Hampton Inn & Suites

GENERAL NOTES,
LEGENDS &
ABBREVIATION

FP001

61G32 REQUIRMENTS

1 RPZ BACKFLOW PREVENTER DETAIL
NOT TO SCALE

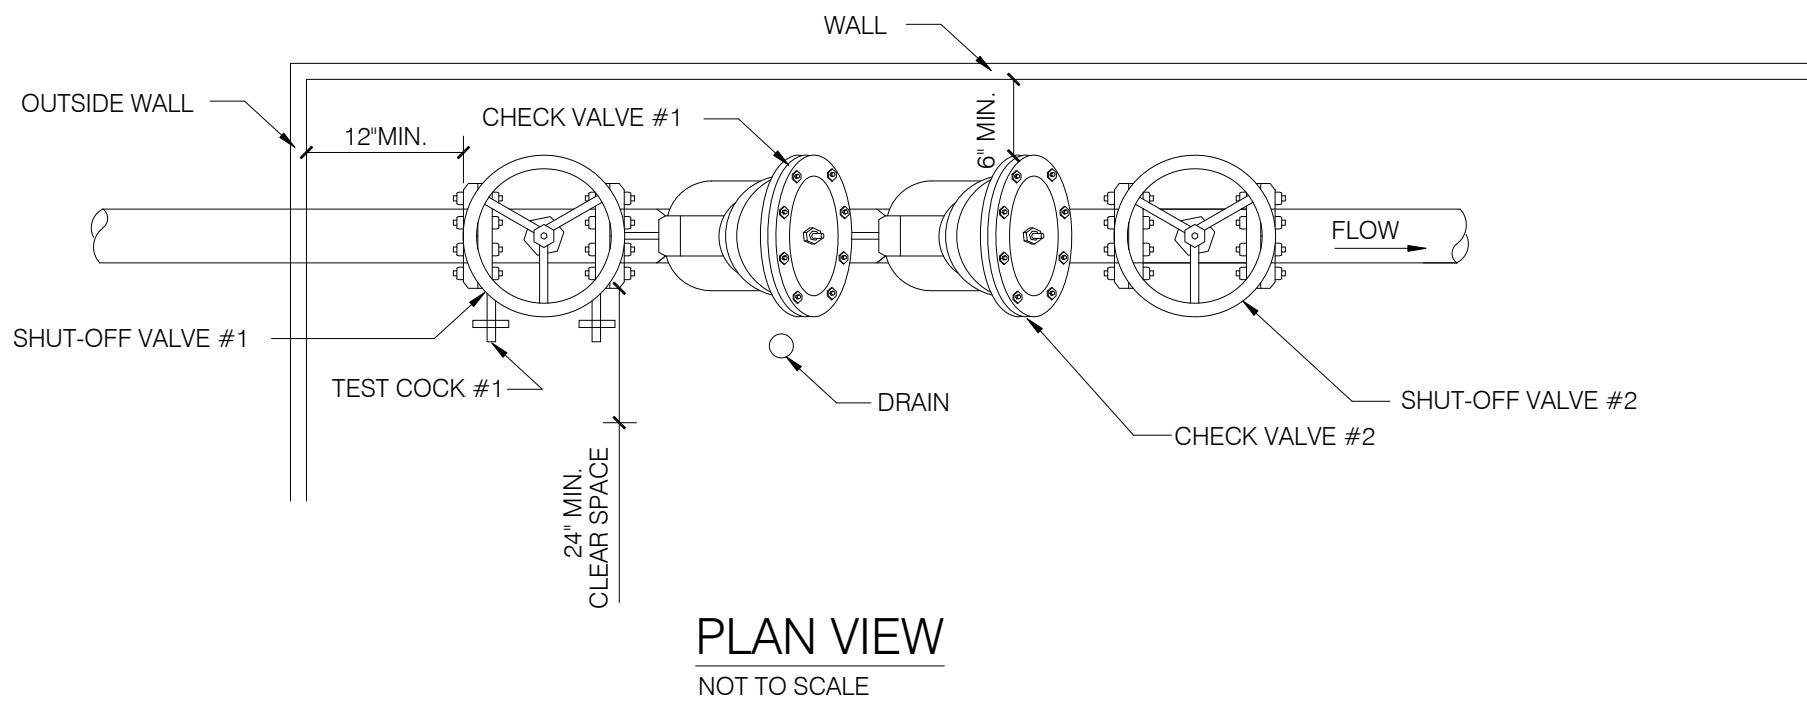
- BACKFLOW PREVENTION AND METERING SPECIFICATIONS AND DETAILS TO MEET LOCAL WATER PURVEYOR REQUIREMENTS INCLUDING MAXIMUM ALLOWABLE PRESSURE DROP.
BASE4 RESPONSE: REFER TO SHEET FP100 DETAIL-1 FOR BFP. WE HAVE PROVIDED A NOTE ON SHEET FP100 BELOW DETAIL-1. "BACKFLOW PREVENTION AND METERING SHALL MEET LOCAL WATER PURVEYOR REQUIREMENTS INCLUDING MAXIMUM ALLOWABLE PRESSURE DROP."

- NO TAPS, BRANCHES, FHS OR OTHER ACCESSORIES ARE PERMITTED ON THE PIPING BETWEEN THE BPA & METER.
- BACKFLOW PREVENTION AND METERING SHALL MEET LOCAL WATER PURVEYOR REQUIREMENTS INCLUDING MAXIMUM ALLOWABLE PRESSURE DROP.

2 AUTOMATIC SPRINKLER ENTRANCE/RISER DETAIL
NOT TO SCALE

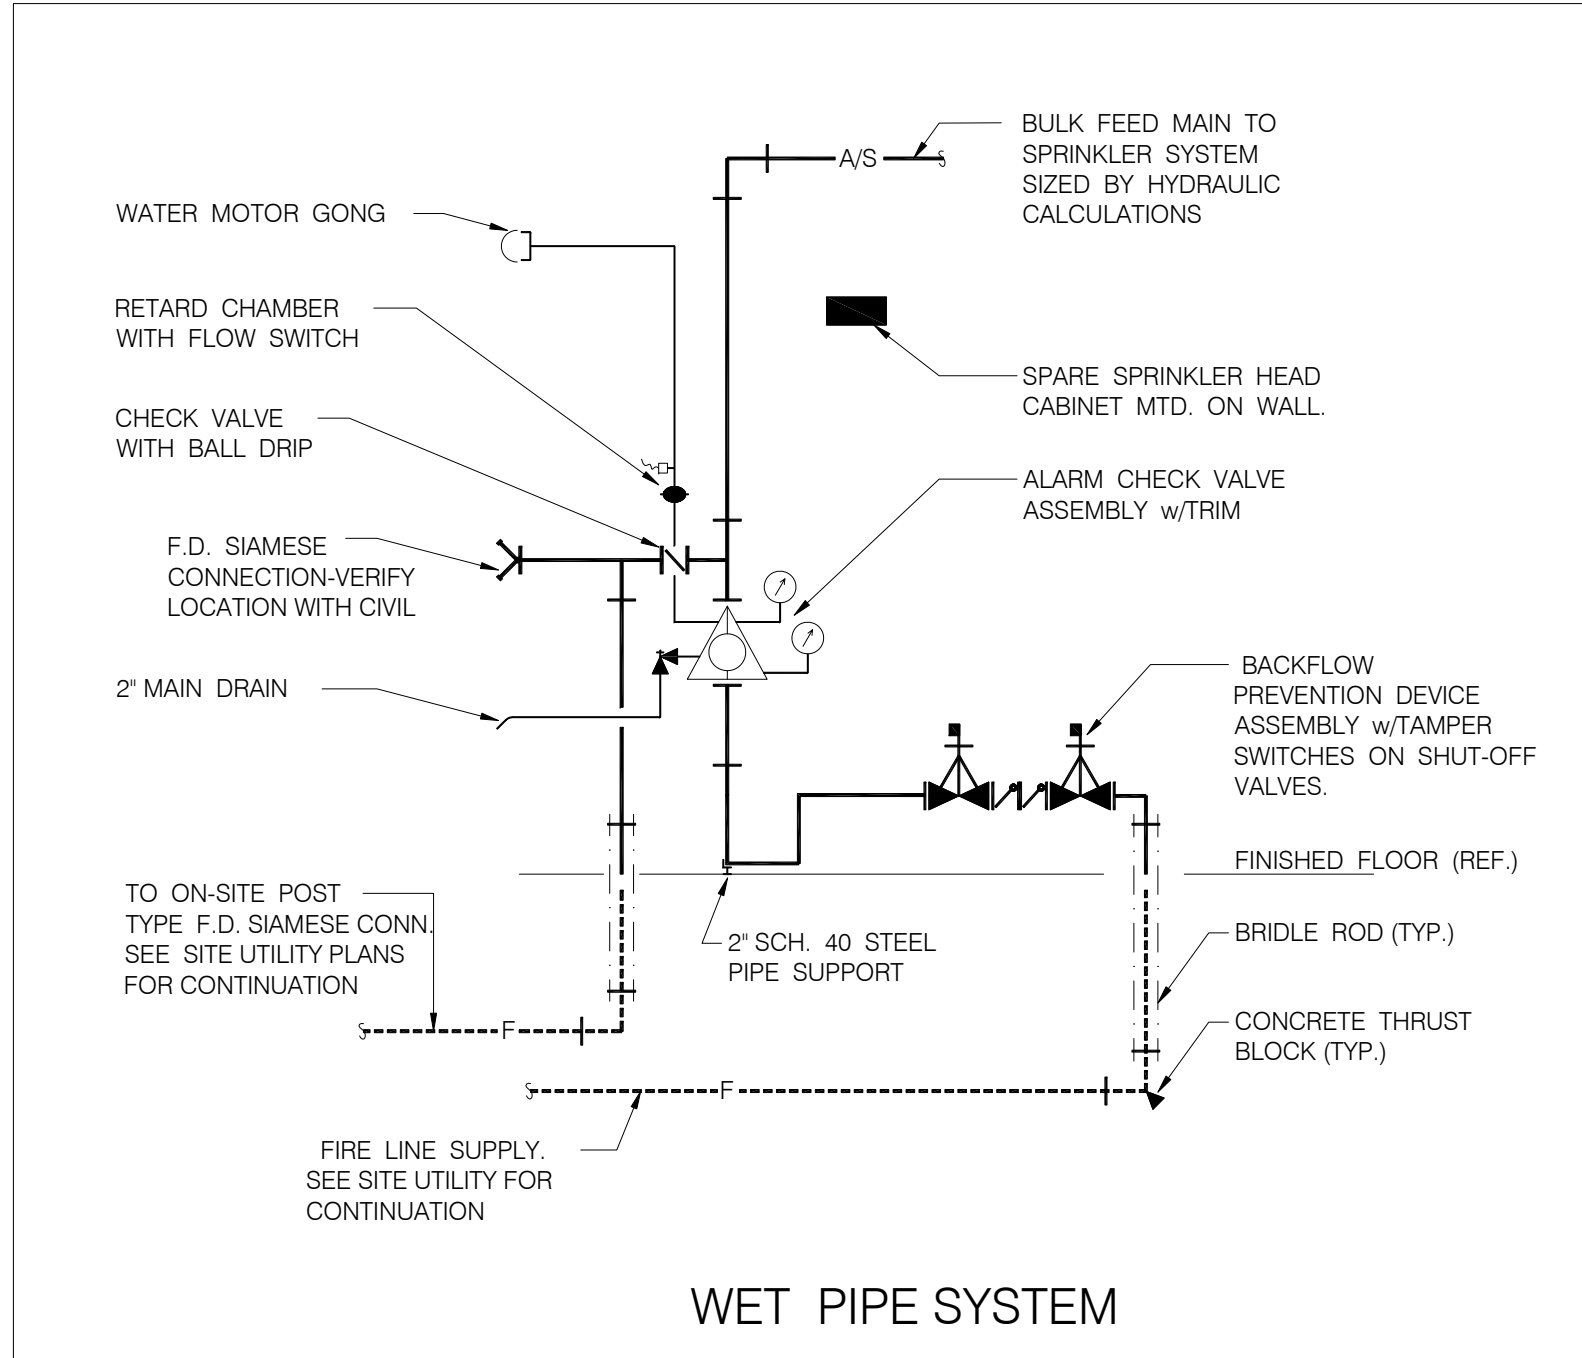
- VALVING AND ALARM REQUIREMENTS TO MINIMIZE POTENTIAL FOR IMPAIRMENTS AND UNRECOGNIZED FLOW OF WATER.
BASE4 RESPONSE: BASE4 HAS PROVIDED VALVES AND WATER SUPPLY ENTRY DETAIL. PLEASE REFER TO SHEET FP001 DETAIL-2.
